SECTION 00 91 15

ADDENDUM NUMBER 6

- 1.01 DATE: APRIL 6, 2021**
- 1.02 PROJECT: WELCOME CENTER**
- 1.03 PROJECT NUMBER: DCM NO. 2020604**
- 1.04 OWNER: ALABAMA A&M UNIVERSITY**
- 1.05 ARCHITECT: NOLA | VAN PEURSEM ARCHITECTS, PC**

SHEET NUMBER
C501

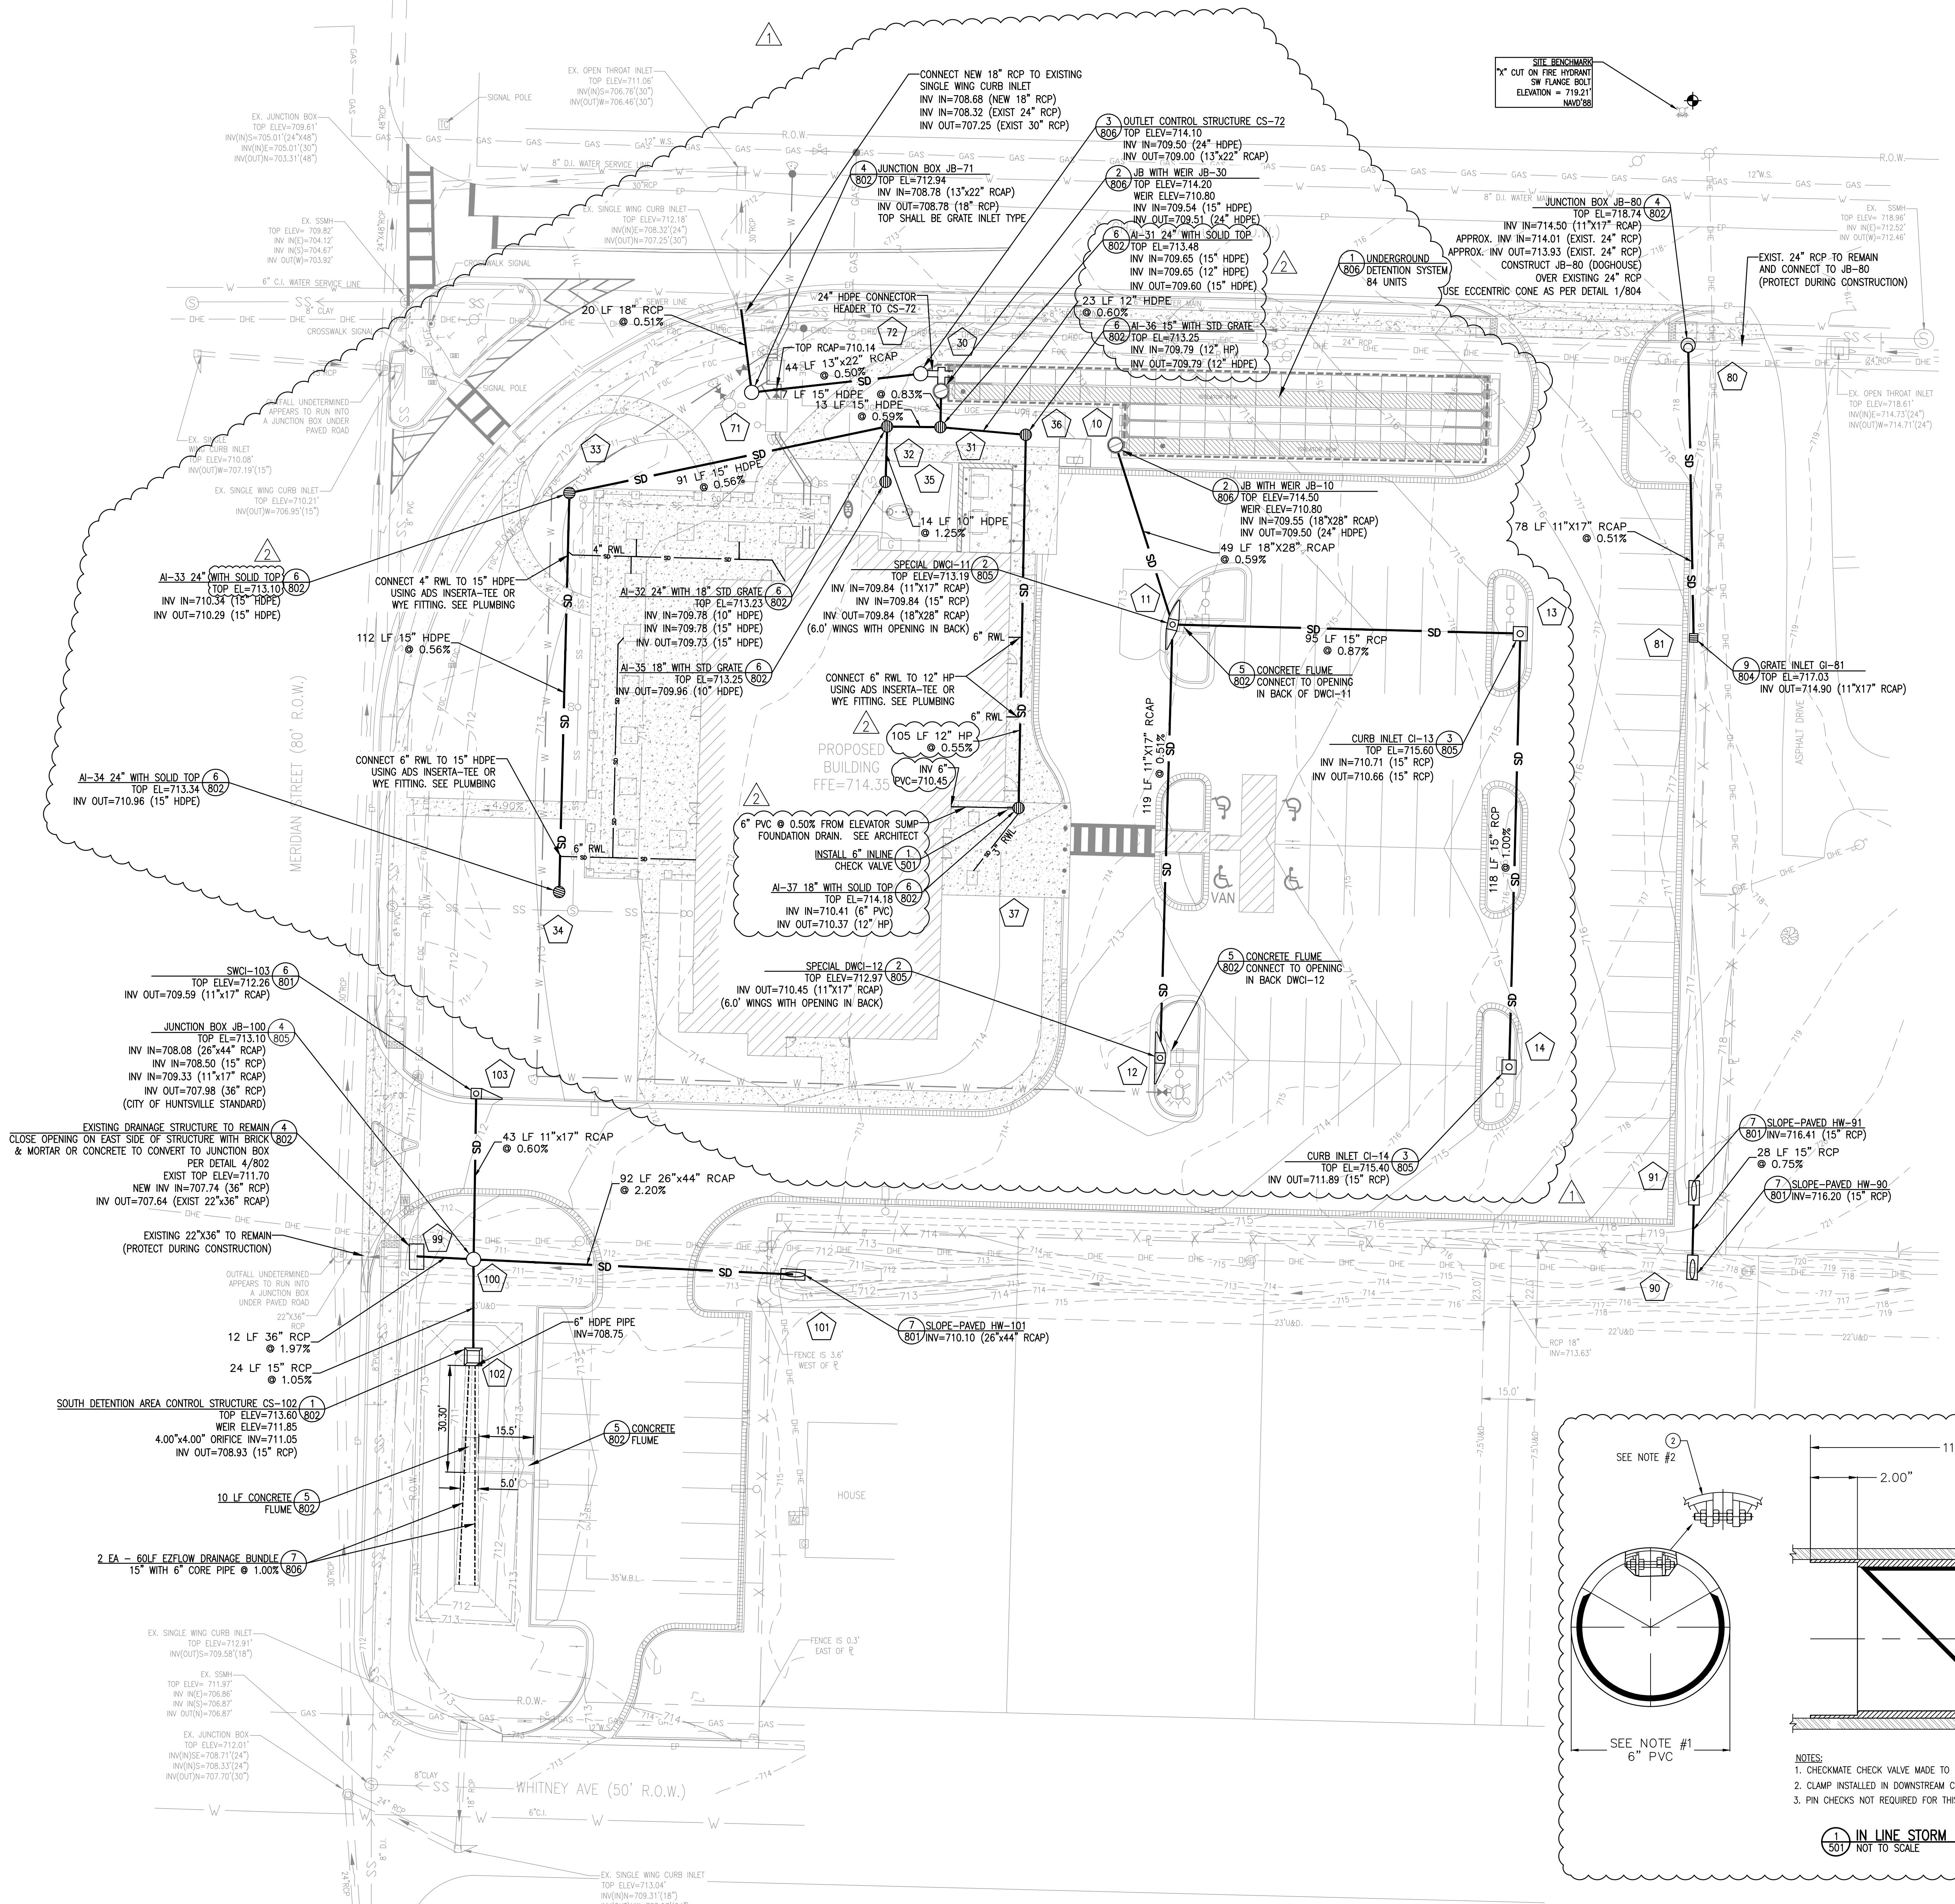
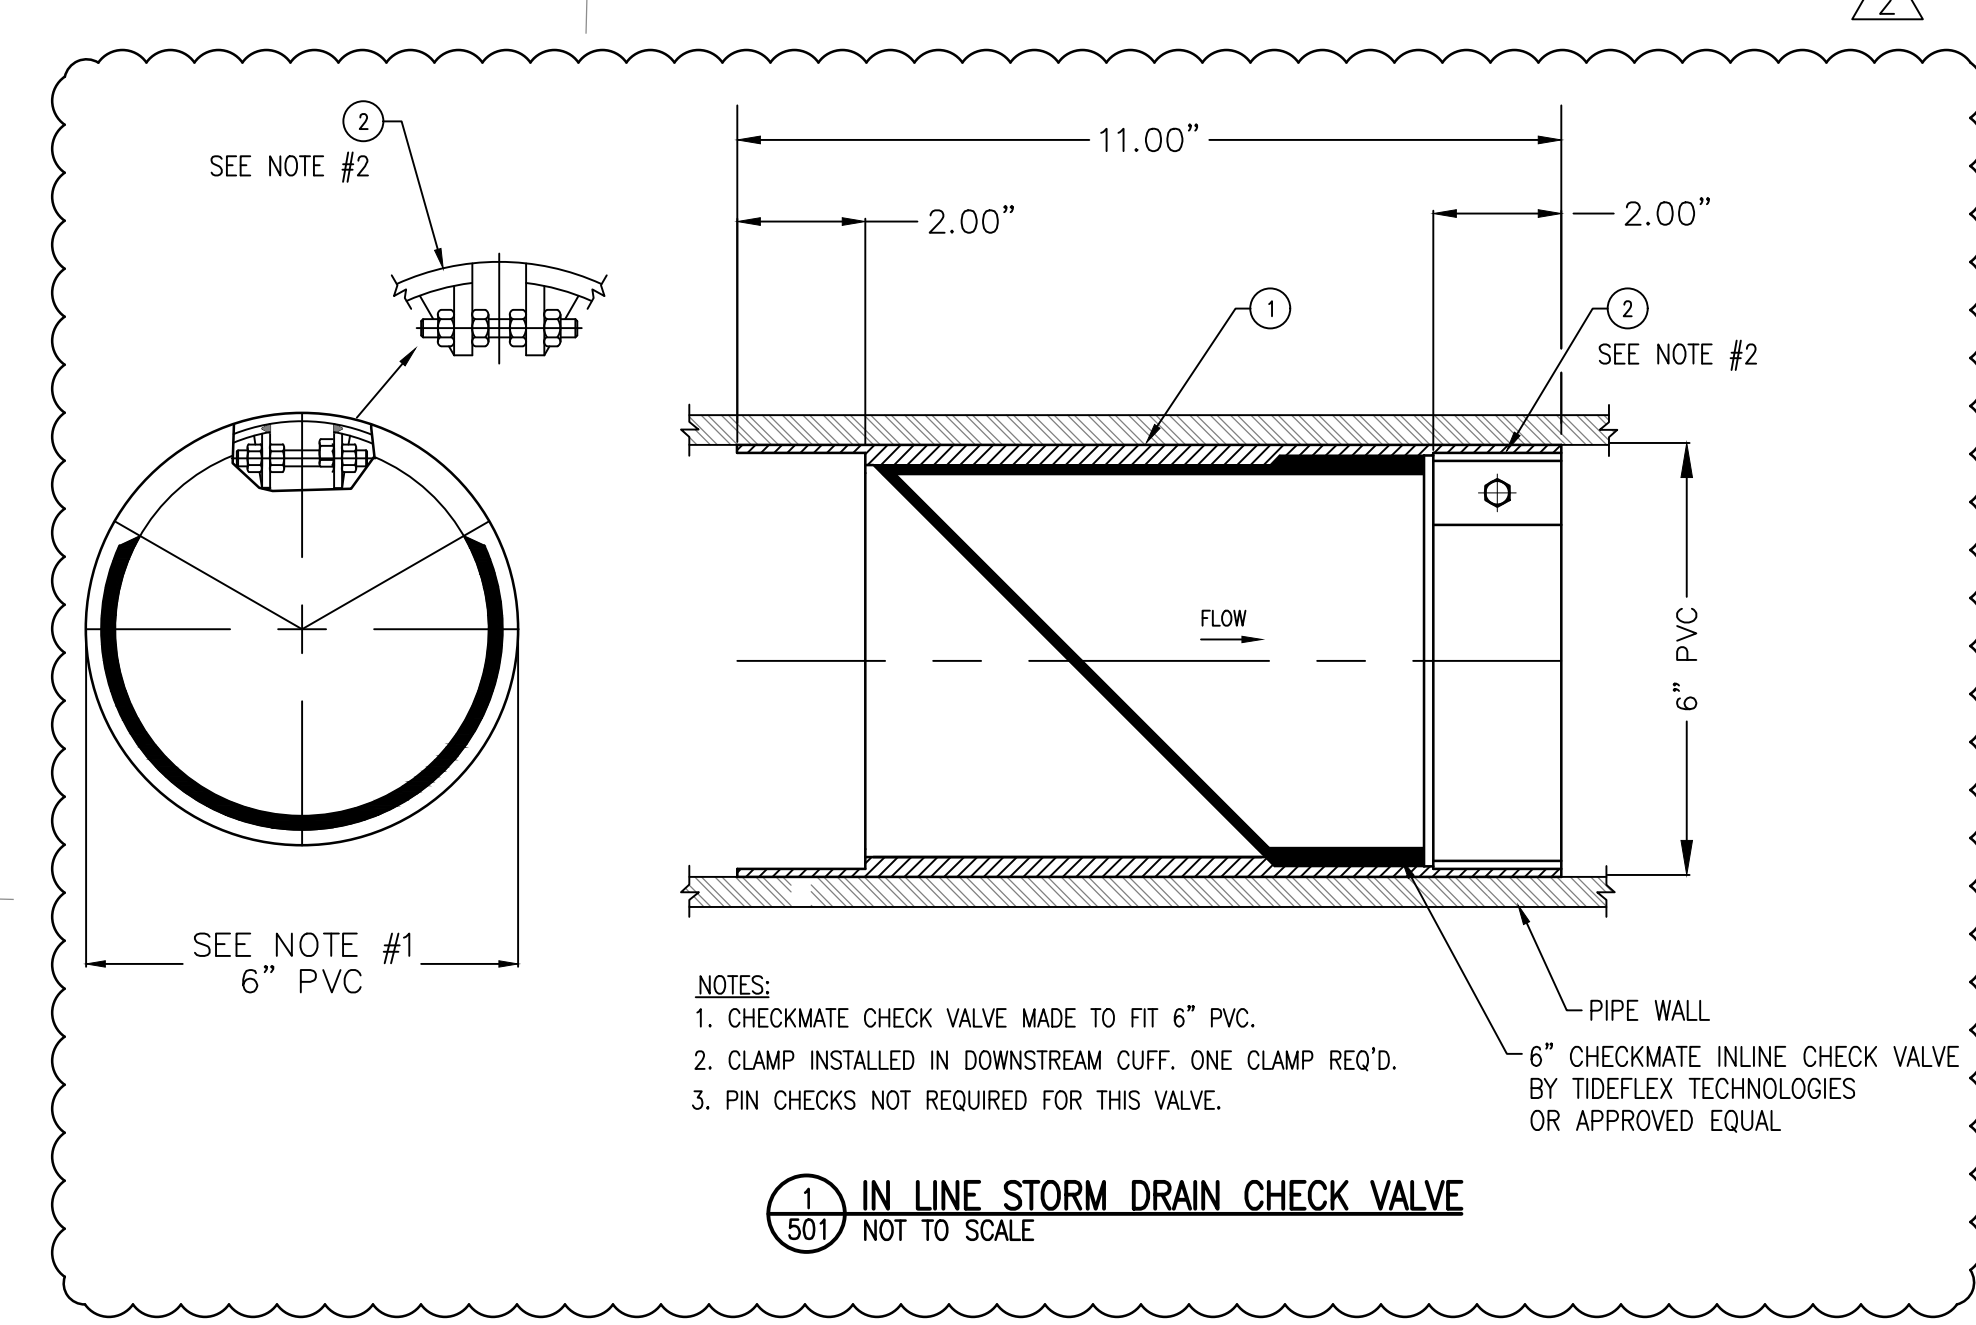
4.01 SHEET C501 – STORM DRAIN PLAN:

- A. Replace this Sheet in its Entirety. Revisions include the following:
1. Modified 12" HDPE invert in AI-31.
 2. Modified slope of 12" HDPE storm pipe P36-31.
 3. Modified inverts in AI-36.
 4. Modified length & slope of 12" HP storm pipe P37-36.
 5. Modified invert in AI-37.
 6. Added 6" PVC foundation drainpipe from elevator sump to connect to P37-36.
 7. Added 6" In line Check Valve in outfall end of 6" PVC foundation drain.
 8. Added Detail 1/C501 -In Line Storm Drain Cheek Valve.
 9. Modified top elevation of AI-33.
